SERVICE LETTER NO. 71-4

DATE: June 4, 1971

- SUBJECTS:
- Item 1. Seat Track Improvements
  - Item 2. Canopy Track Improvements
  - Item 3. Windshield/Canopy Hardware Improvements
  - Item 4. Exhaust Joint Sealing
  - Item 5. Nose Gear Inspection and Precautions
  - Item 6. Nose Gear Strut Sealing
  - Item 7. Static System Improvements
  - Item 8. Air Vent Improvements
  - Item 9. Fuel Selector Valve Lubrication
  - Item 10. Lycoming Service Instructions 1070C and 1237

Figure 1. Seat Track Modification

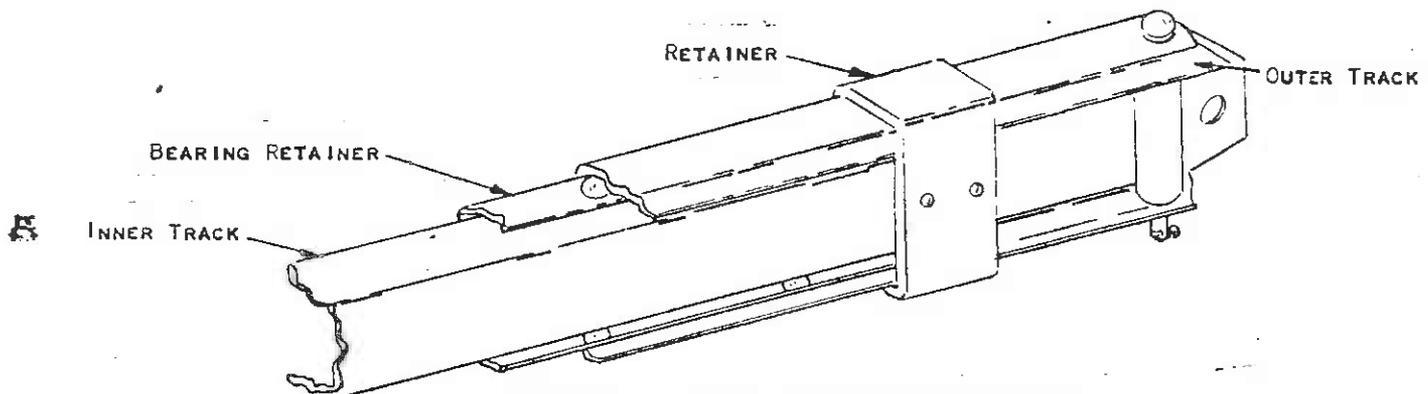
Reports from the field indicate that, in some instances, seat track binding has occurred on aircraft subjected to excessive aft loads on the seat backs. Binding is caused by twisting and eventual bending of the outer track which allows the seat track bearings to drop out.

Improved seat track assemblies have been developed which incorporate retainers (3 per seat), riveted to the ends of the inner track and enclosing the outer track. The retainers prevent the outer track from springing and twisting when excessive aft loads are exerted against the seat back (see figure 1).

Figure 2. Canopy & Windshield Hardware Improvement

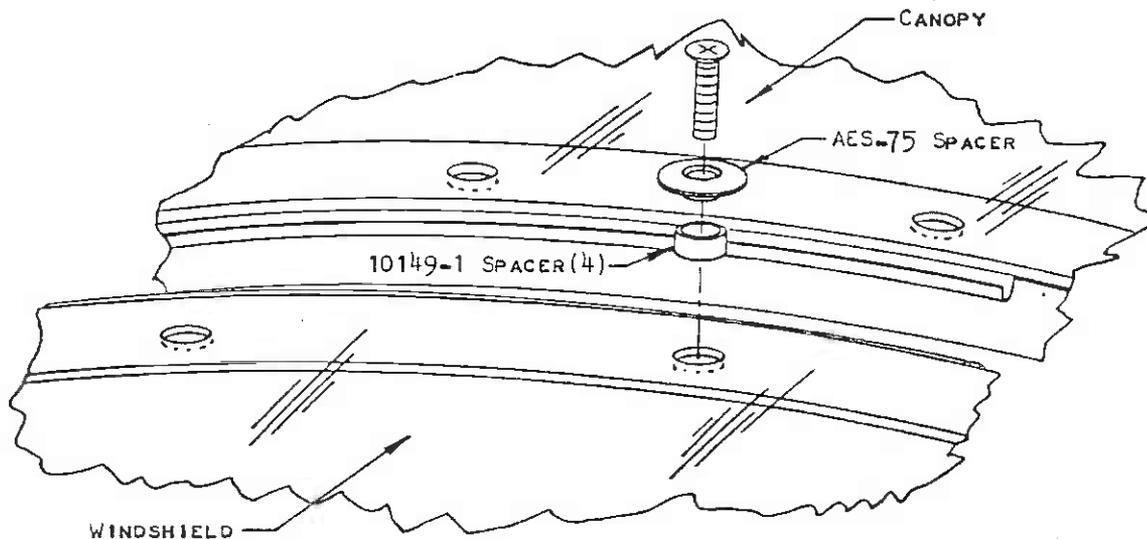
Spacers, part no. 10149-1 can be ordered (no charge), from your American Aviation Corp. dealer, four (4) required per aircraft. Aircraft not shown on the above serial no. list, do not require the installation of the spacers.

Figure 3. Nose Gear Inspection

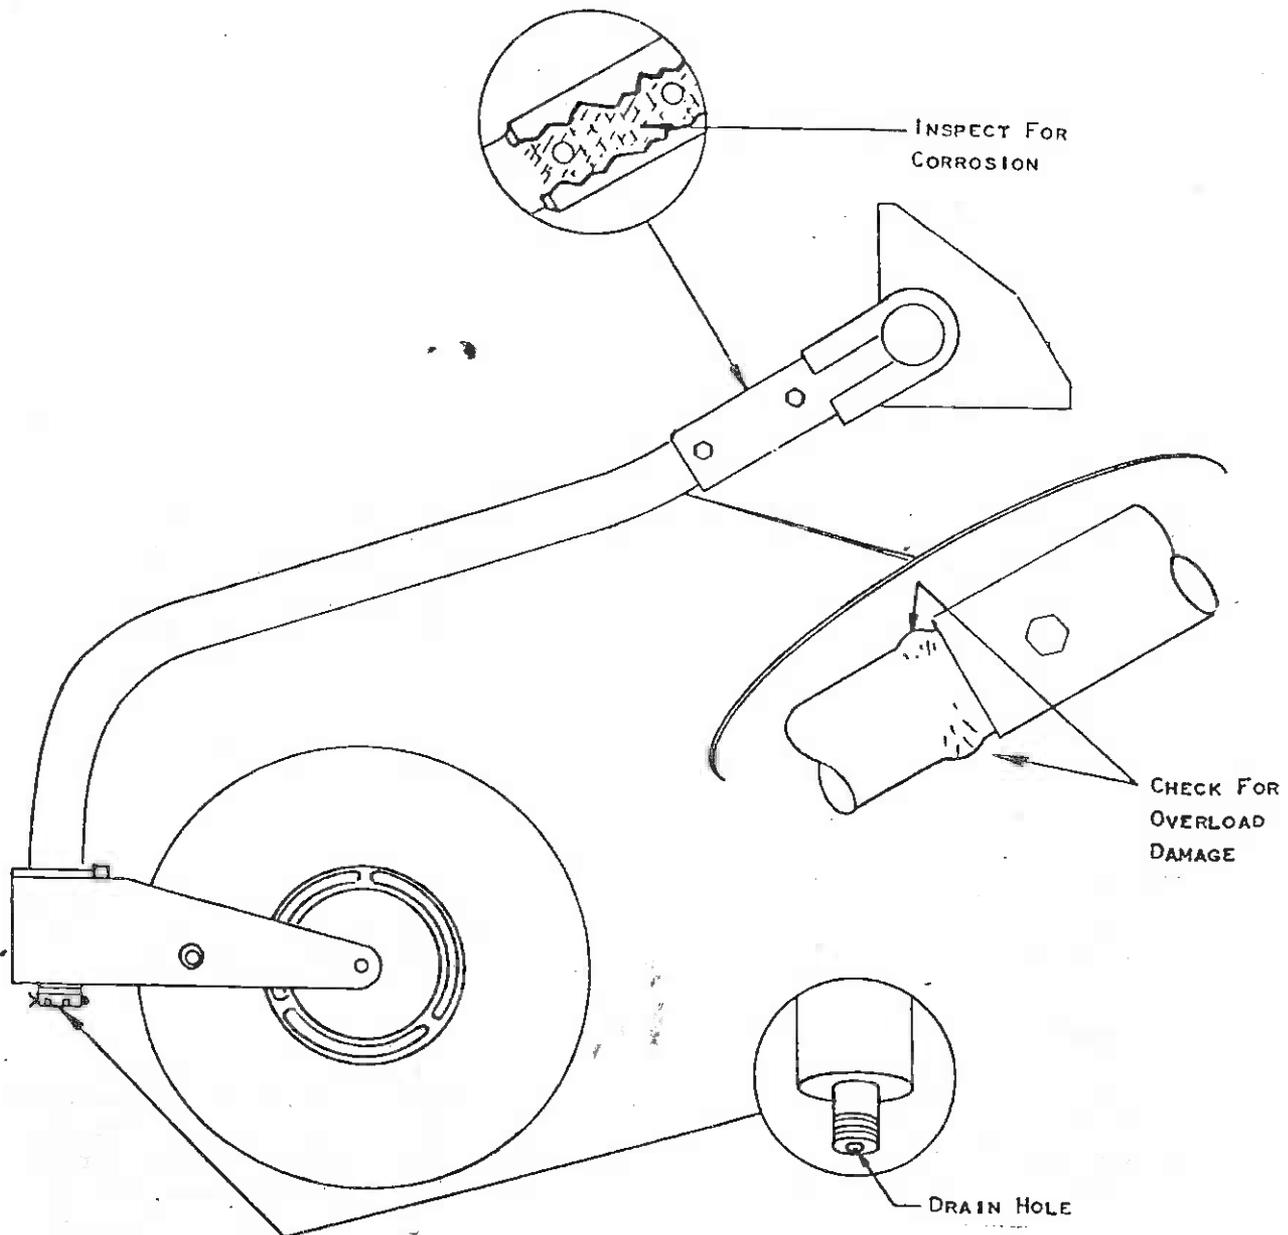
Item 5. Nose Gear Inspection and Precautions (All AA-1 and AA-1A) (Figure 3)

- a. Loosen nose gear boot and inspect strut for evidence of overload damage in the area shown:
- b. Check strut for looseness in torque tube yoke. If loose, replace bolts (NAS464P6A28). If new bolts do not eliminate looseness, ream to next larger size NAS bolt (NAS464P7 maximum).
- c. Check drain hole at lower end of strut to insure it is open. One method is by running a .125" drill bit through the hole to clean out any foreign

Figure 4. Nose Gear Strut Sealing

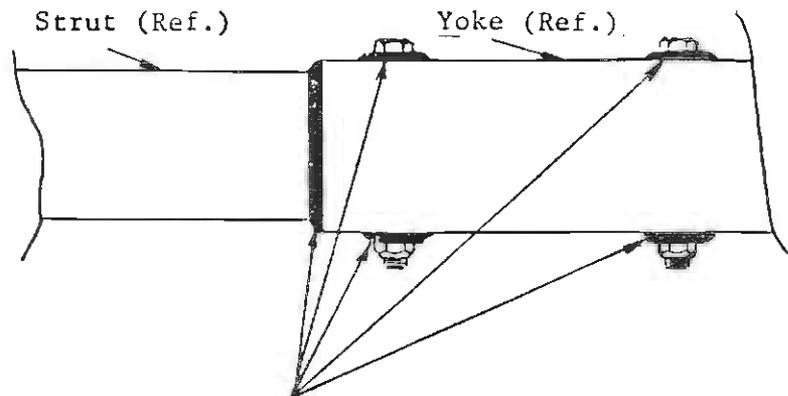
At next inspection and any time strut is removed, it is recommended that the nose gear strut be sealed at the strut/torque tube yoke joint to prevent water from entering the strut from inside the cabin. Clean the area thoroughly and apply sealant\* to the joint and around bolt heads as shown on figure 4.

Apply sealant (RTV 102 by General Electric or 732 RTV by Dow-Corning) on bolts and strut to torque tube connection. At next inspection and any time strut is removed.

Figure 6. Air Vent Sealing and Adjustments

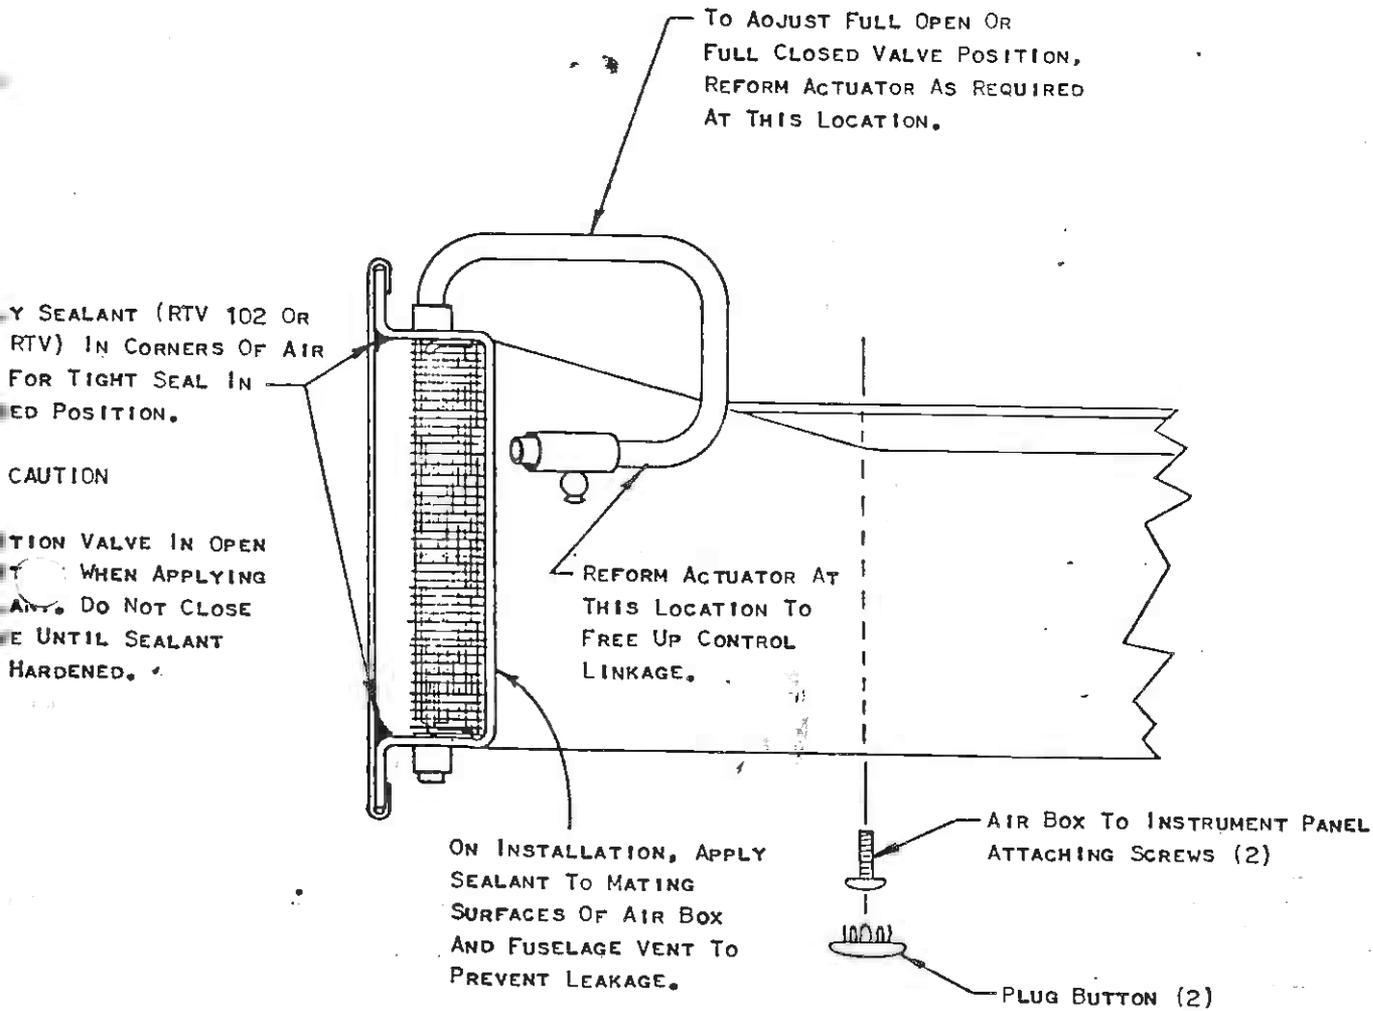
To provide more control rod travel toward the closed position, a spacer, part no. 10165-1, has been added on current production aircraft, between the shaft shoulder and the control knob. This provides 1/4 inch more rod travel and assures the valve fully closing when properly adjusted. Spacer, part no. 10165-1 can be ordered (no charge), from your authorized American Aviation Corporation dealer.

If required, adjustments of the air vent control are accomplished by removing the air vent assembly and reforming the actuator as shown on figure 6. To remove the airbox, take out the two plug buttons located under the box, (figure 6) near the front, and using a long Phillips screwdriver, remove the screws attaching the airbox to the instrument panel. On installation, reseal the airbox to the fuselage with sealant (RTV102 by General Electric or 732 RTV by Dow Corning).

Figure 7. Fuel Selector Valve,  
exploded view

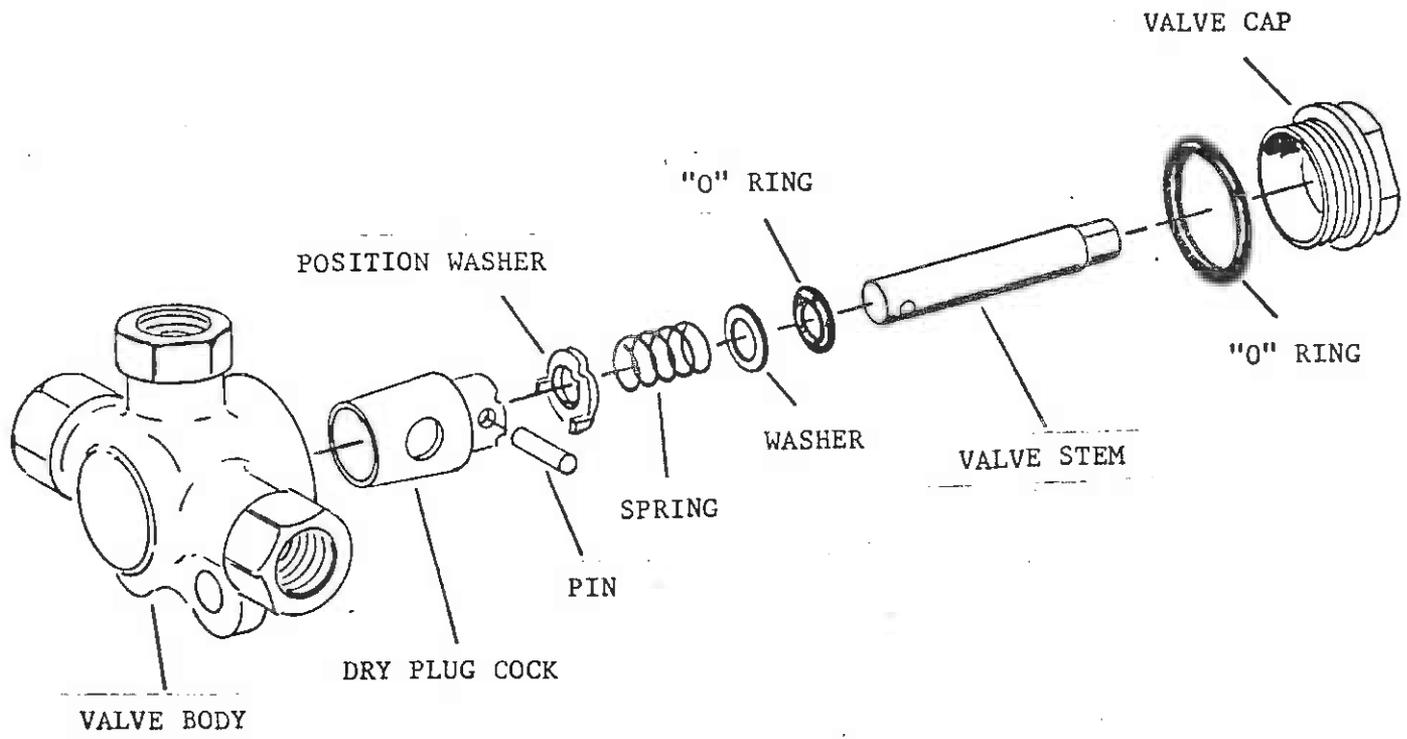
It is recommended that the fuel selector valve be disassembled, cleaned and lubricated each 500 hours of operation or sooner if the valve becomes difficult to operate.

The clean, dry valve plug cock should be lubricated with a very light film of plug cock lubricant conforming to MIL-G-6032\*. The plug should be inserted and turned several times and all surplus lubricant removed from the valve ports prior to reassembly. It is not necessary to drain the fuel system when servicing the fuel selector valve, however, a small container should be placed under the valve to collect residual fuel. See figure 7 for identification of fuel selector valve parts.
